BULLETIN NO.  
**91-040**

## Automatic Transmission Breather Tube Modification

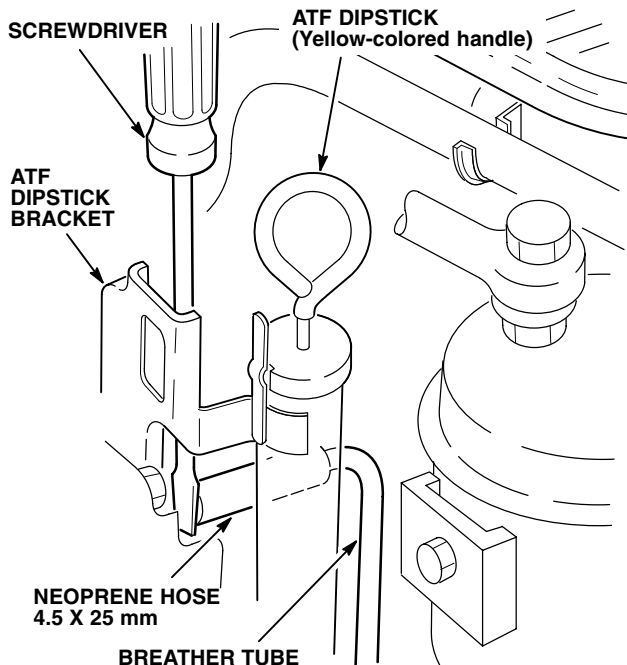
The neoprene hose end of the automatic transmission breather tube is too close to, or blocked off by, the ATF dipstick bracket.

Inspect all vehicles within the affected VIN range for a blocked off breather tube hose. If the breather tube hose is blocked, do the following:

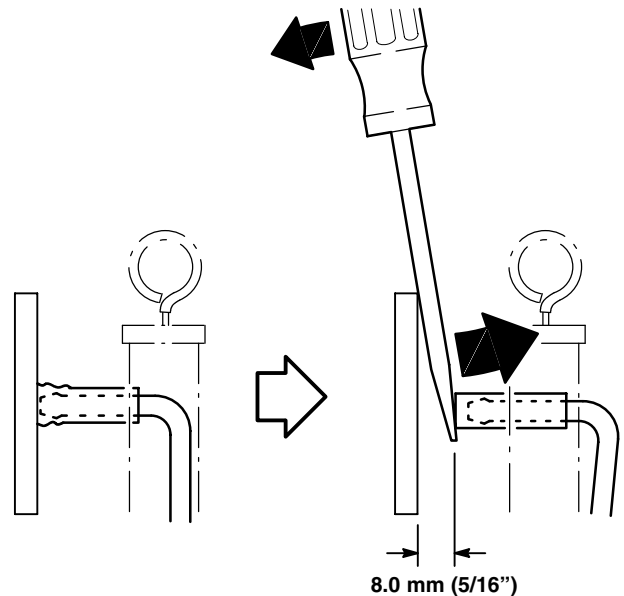
1. Locate the transmission breather tube. It is to the right of the ATF dipstick (yellow-colored handle).
2. Insert a flat-tip screwdriver between the breather tube and the ATF dipstick bracket.

3. Bend the breather tube about 8.0 mm (5/16") away from the ATF dipstick bracket. Check the end of the breather tube once the screwdriver is removed, to be sure the breather tube does not spring back.
